# SERVICE BULLETIN

from: TRIO-KENWOOD COMMUNICATIONS, INC.

SUBJECT: TS-120S VOX OPERATION PICK-UP TIME

DATE 7/10/79

## ▼ RF UNIT (X44-1260-01)

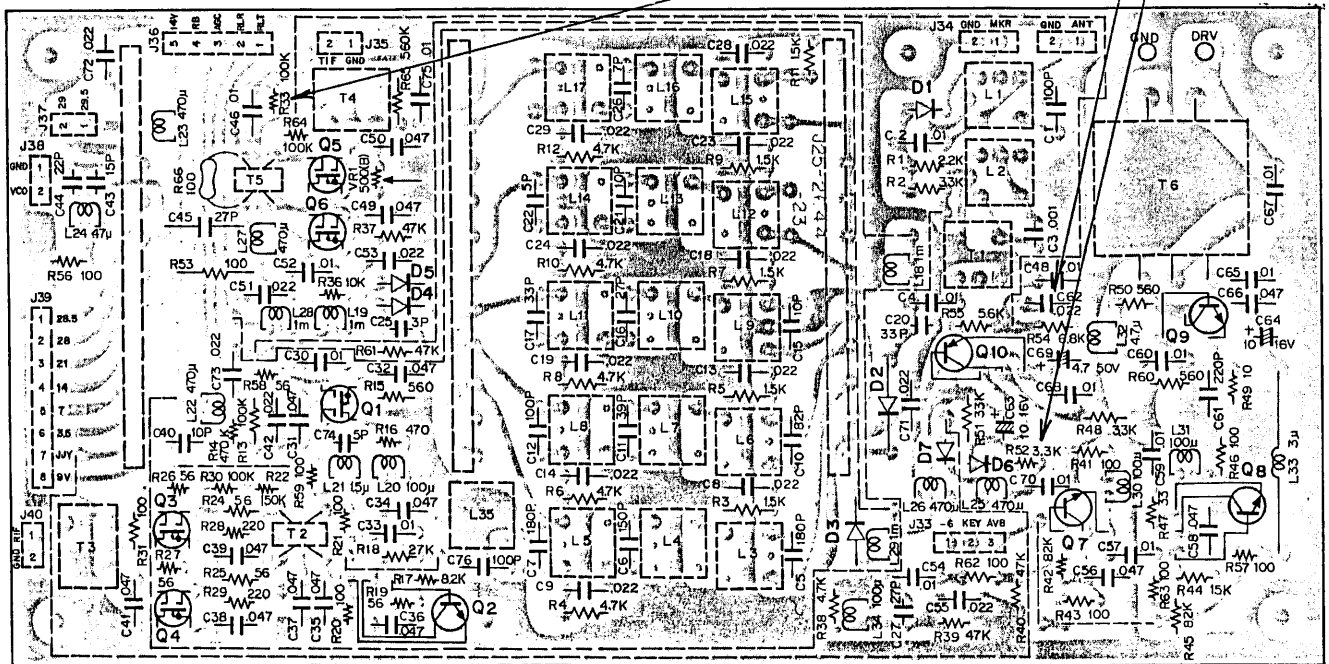
High speed CW OPS may inquire about partial loss of the first character when operating VOX-CW. The transceiver will operate up to about 20WPM before this is apparent.

Improvement may be had by changing three components on the RF unit, X44-1260-01.

R33 100K ohm, change to 150K ohm  
R52 33K ohm, change to 4.7K ohm  
C62 .022uF, change to 1uF @ 50V

Production later than Serial # 940701 has this change.
